LOCK AND DAM NO. 9

SUPPLEMENT NO. 2

DESIGN MEMORANDUM NO. 1, GENERAL
FISH AND WILDLIFE FACILITIES
AT HOLLA BEND
NATIONAL WILDLIFE REFUGE

U. S. ARMY ENGINEER DISTRICT, LITTLE ROCK
CORPS OF ENGINEERS
LITTLE ROCK, ARKANSAS
NOVEMBER 1968

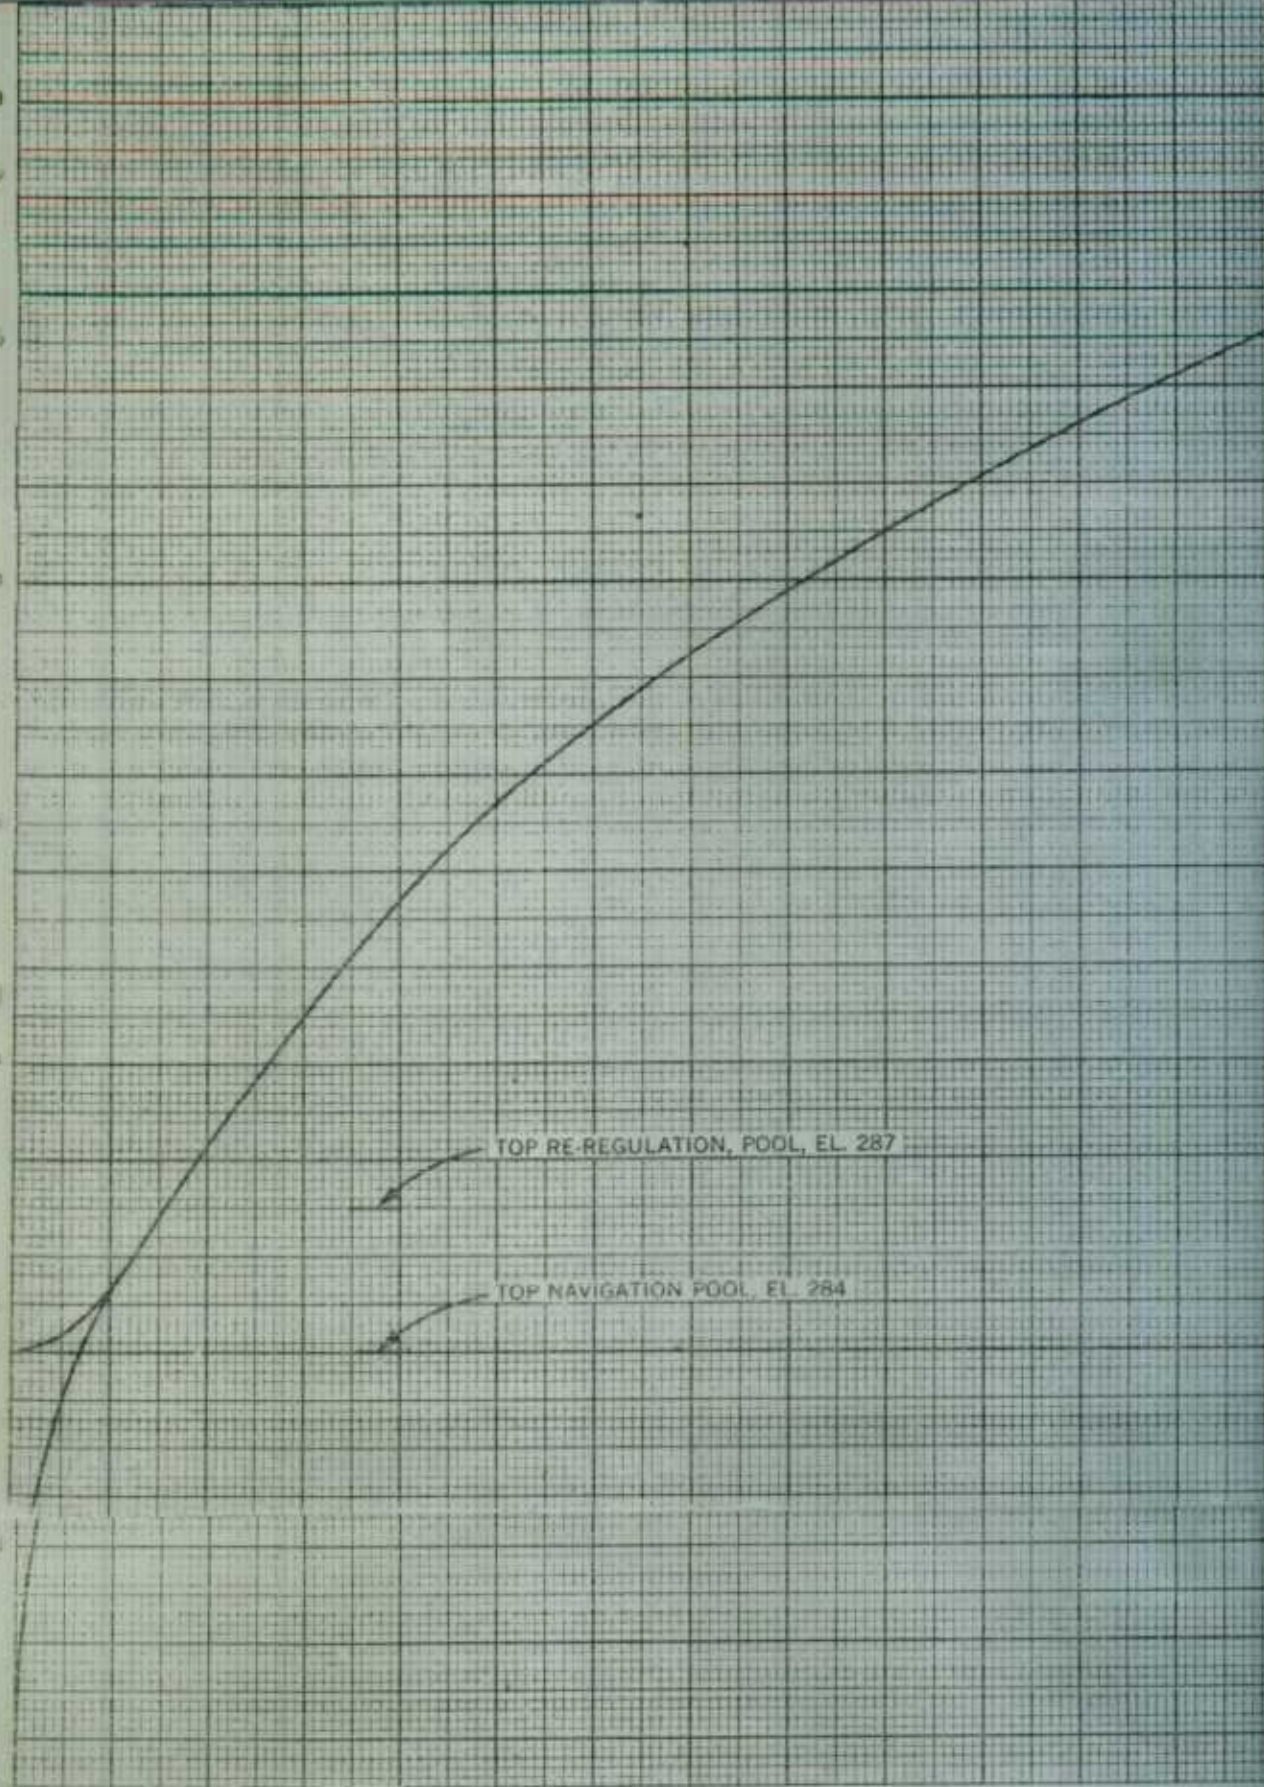
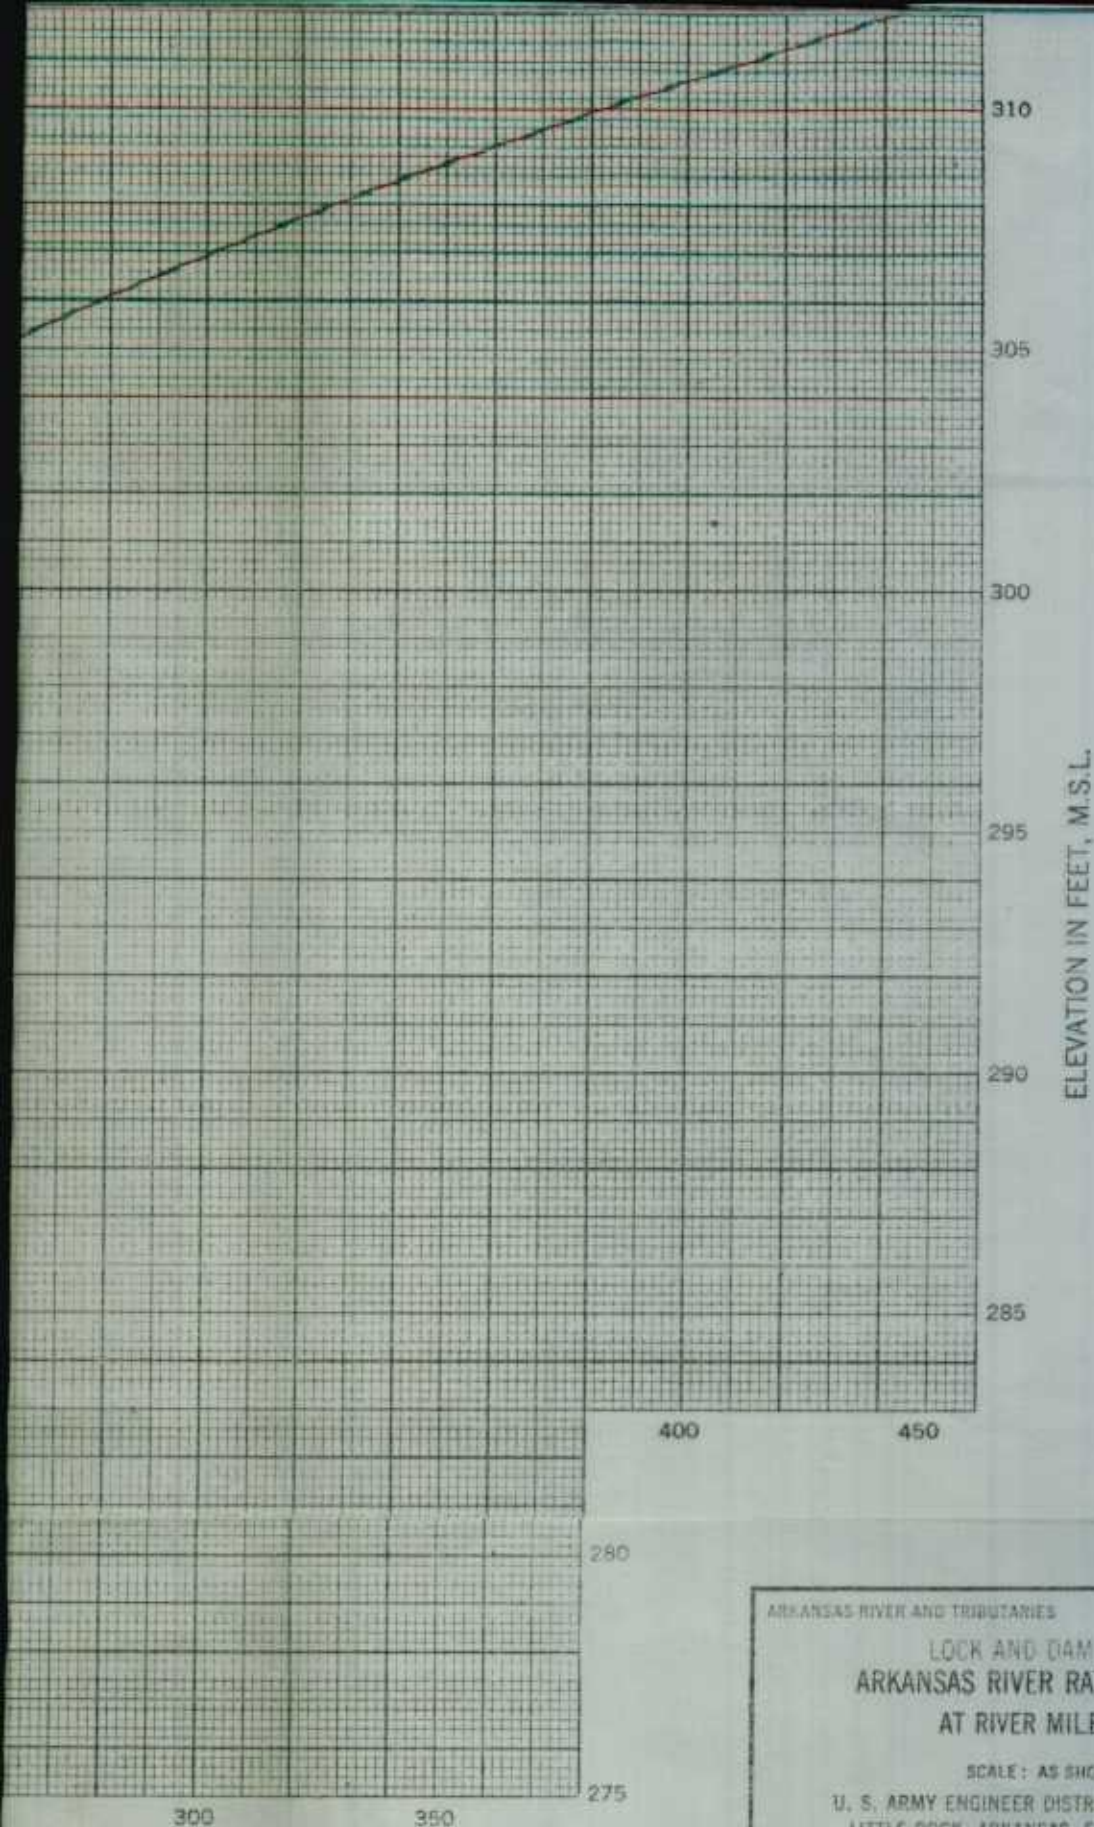
3. Paragraph 4-10b and Plate 4. The proposed top grade of the riverside cofferdam at elevation 298 feet msl is stated to protect the work area against a flow of 150,000 cfs with a freeboard of 0.5 feet. However, the rating curve shown on plate 4 for the Arkansas River at river mile 241, which is adjacent to the cofferdam, indicates that a discharge of 150,000 cfs would produce a water surface elevation at about 299.2 feet msl. This apparent discrepancy should be clarified.
